ADMINISTRATIVE AMENDMENT

FILE # ^{SI-2020}₋₀₀₇₅₅ **PROJECT #** ^{PR-2019}₋₀₀₁₉₉₆

DURANGO

Site Plan for Subdivision

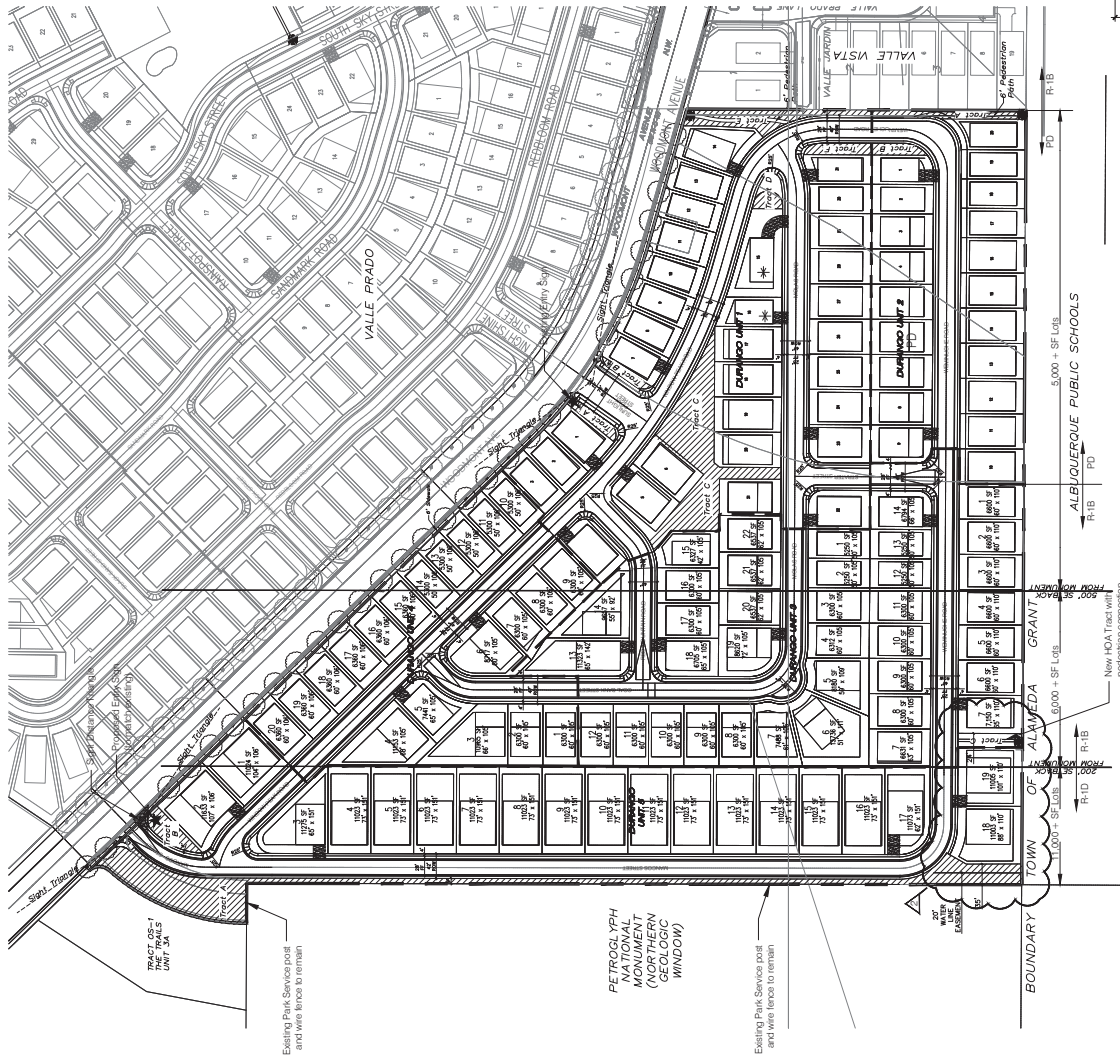
A ADMINISTRATIVE AMENDMENT:

- ELIMINATION OF HILLERMAN STREET CONNECTION TO TIERRA ANTIGUA E.S.
- CREATION OF HOA TRACT WITH PEDESTRIAN CONNECTION TO TIERRA ANTIGUA E.S.
- SHIFT UNIT 51 LOTS 18 AND 19 TO ACCOMMODATE EXC1 USMF 20 WATER LINE EASEMENT
